CITY OF NAPOLEON  
 BUILDING DEPT.  
 Plan Approval  
 By *[Signature]* Date 1-23-81

230 Glenwood

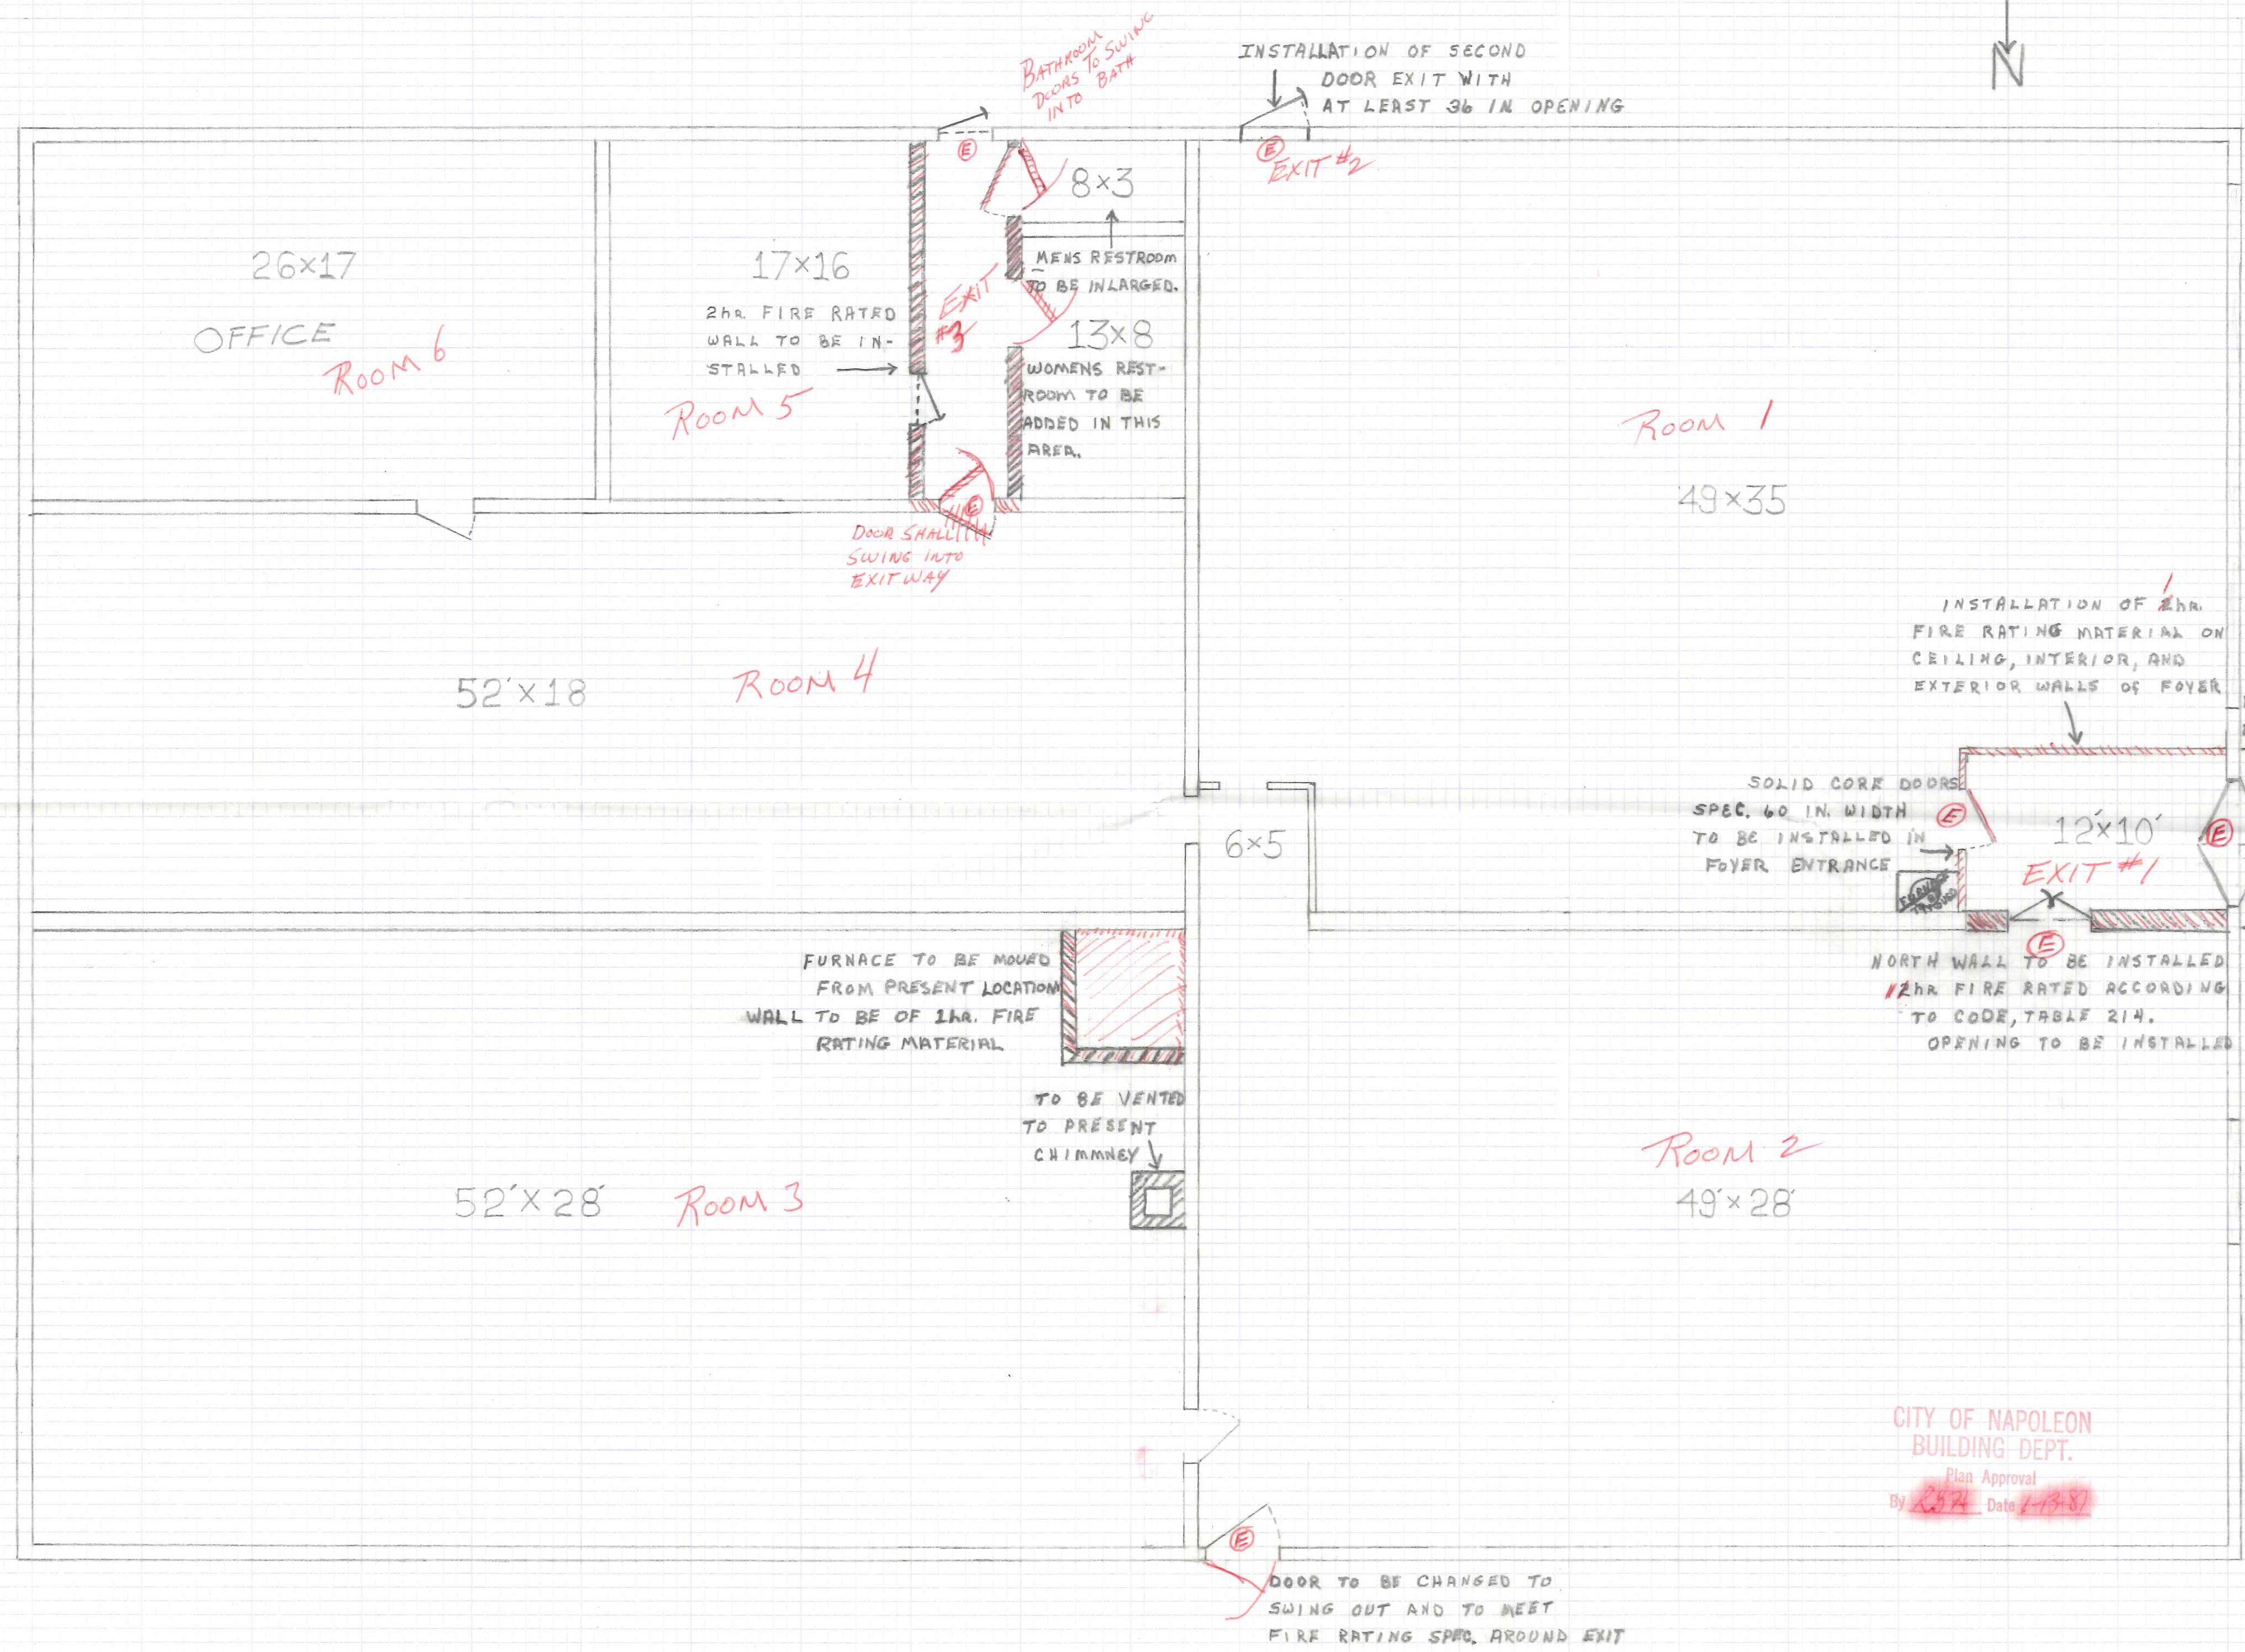
See enclosed for  
Spec. No. 87  
Change of Code

17x16  
2hr. FIRE RATED  
WALL TO BE IN-  
STALLED  
Room 5

BATHROOM  
DOORS TO SWING  
INTO BATH

INSTALLATION OF SECOND  
DOOR EXIT WITH  
AT LEAST 36 IN OPENING

DOOR SHALL  
SWING INTO  
EXITWAY

FURNACE TO BE MOVED  
FROM PRESENT LOCATION  
WALL TO BE OF 1hr. FIRE  
RATING MATERIAL

TO BE VENTED  
TO PRESENT  
CHIMNEY

INSTALLATION OF 1hr.  
FIRE RATING MATERIAL ON  
CEILING, INTERIOR, AND  
EXTERIOR WALLS OF FOYER

AWNING TO BE  
ADDED ABOVE  
FRONT ENTRANCE

SOLID CORE DOORS  
SPEC. 60 IN. WIDTH  
TO BE INSTALLED IN  
FOYER ENTRANCE

PANIC HARDWARE  
TO BE INSTALLED  
ON FRONT DOORS,  
DOORS TO  
SWING OUT

NORTH WALL TO BE INSTALLED  
1/2hr. FIRE RATED ACCORDING  
TO CODE, TABLE 214.  
OPENING TO BE INSTALLED

DOOR TO BE CHANGED TO  
SWING OUT AND TO MEET  
FIRE RATING SPEC. AROUND EXIT
